URGENT FIELD SAFETY NOTICE

Subject: Incorrect handling of non-square Image pixel spacing in Enterprise Imaging XERO Viewer at initial load leads to incorrect placement of reference lines.

- Enterprise Imaging XERO Viewer (UDI-DI: 05400874000710)

Figure 1: Example of placement difference due to incorrect initialization in XERO Viewer

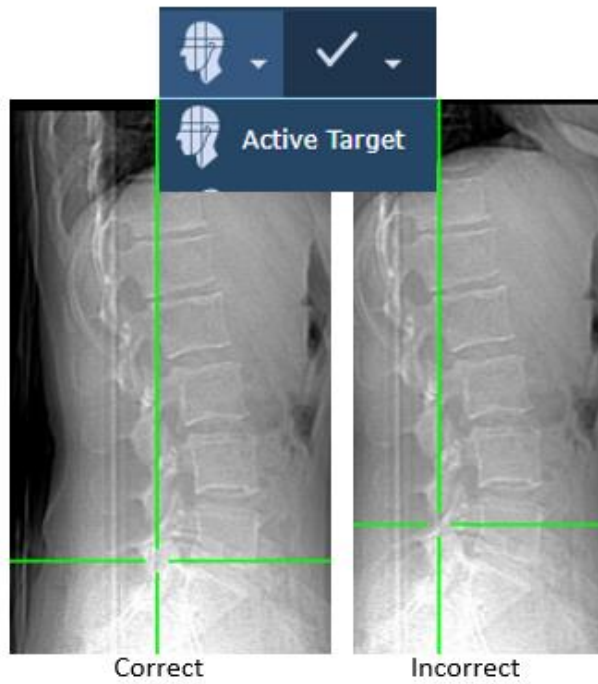
When an image has non-square pixel spacing, the reference/localizer line is incorrectly placed on the scout image in the XERO Viewer (offset from actual position). For example, when viewing a CT localizer radiograph, also known as a scanogram or scout image in the sagittal plane next to an axial series, the localizer/scout line or the active target localization tool may display the incorrect crosshair/line position on the non-coplanar/scout image with respect to the axial slice location.

This misplacement occurs only initially when viewing the anatomy in the non-coplanar image within XERO Viewer. When a user scrolls through other available scout/non-coplanar images in a series, or replaces the current image in the display area with another series and then returns to the first scout image viewed, the reference/localizer line or active target crosshair will subsequently be correctly placed.

Example of reference line placement difference in an affected study

Example of Active Target placement difference in an affected study

AGFA HealthCare will provide the software corrections for the affected versions. A patch is available for each of the following XERO Viewer version streams:

- Use the XERO Viewer Extended Tools component (Xtend), if enabled.
- Use the Enterprise Imaging Desktops viewer
- Scroll through other available scout/non-coplanar images in a series, or replace the current image in the display area with another series in order to correct any potentially misplaced scout line.
